25% Precomp Cutback Level Proposal

SCSI Parallel Working Group

T10/01 - 136r0

Specification Limit and 80 mv Distribution

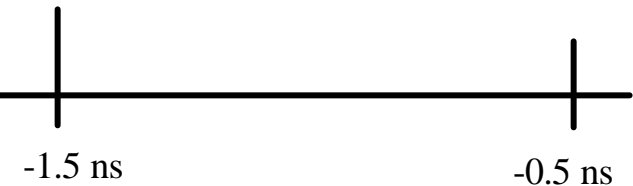
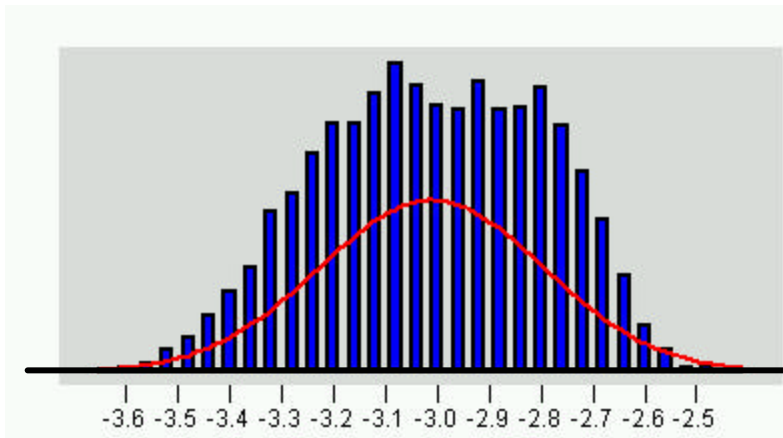
25% Cutback

Spec limit = -1.5 nsec

$$-3.01047 - (-1.5) = -1.51047$$

$$1.51047 / .21738 = 6.95 \text{ sigma}$$

Specification Limit and 130 mv Distribution

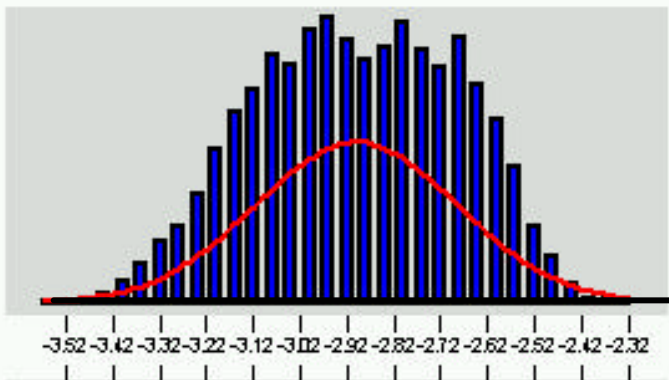
25% Cutback

Spec limit = -1.0 nsec
 $-2.89924 - (-1.0) = -1.89924$
 $1.89924 / .21751 = 8.73$ sigma

Specification Limit and 80 mv Distribution

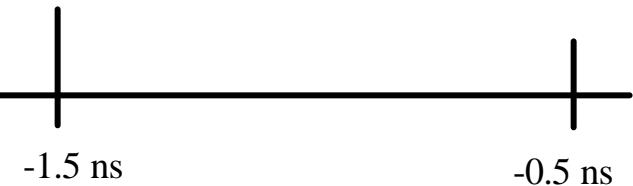
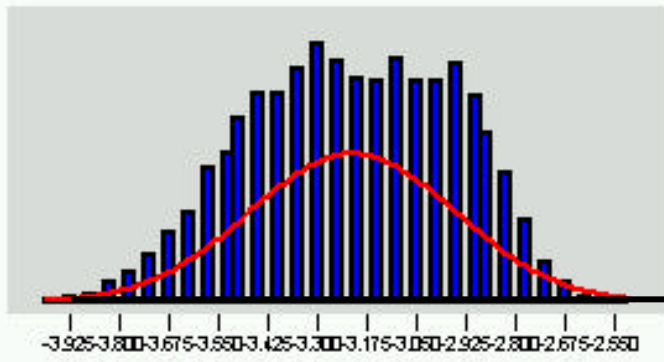
50% Cutback

Spec limit = -1.5 nsec

$$-3.21257 - (-1.5) = -1.71257$$

$$1.71257 / .26086 = 6.57 \text{ sigma (Vs. 6.95)}$$

Specification Limit and 130 mv Distribution

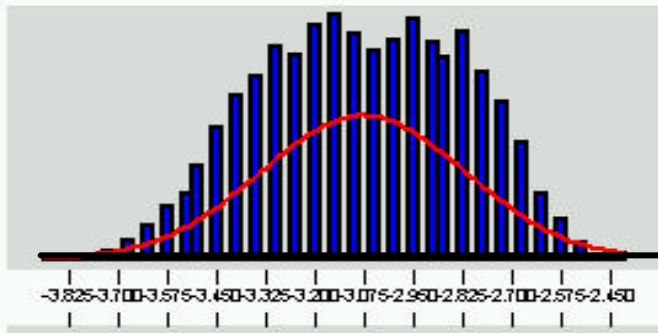
50% Cutback

Spec limit = -1.0 nsec

$-3.07909 - (-1.0) = -2.07909$

$2.07909 / .26101 = 7.97$ sigma (Vs. 8.73)
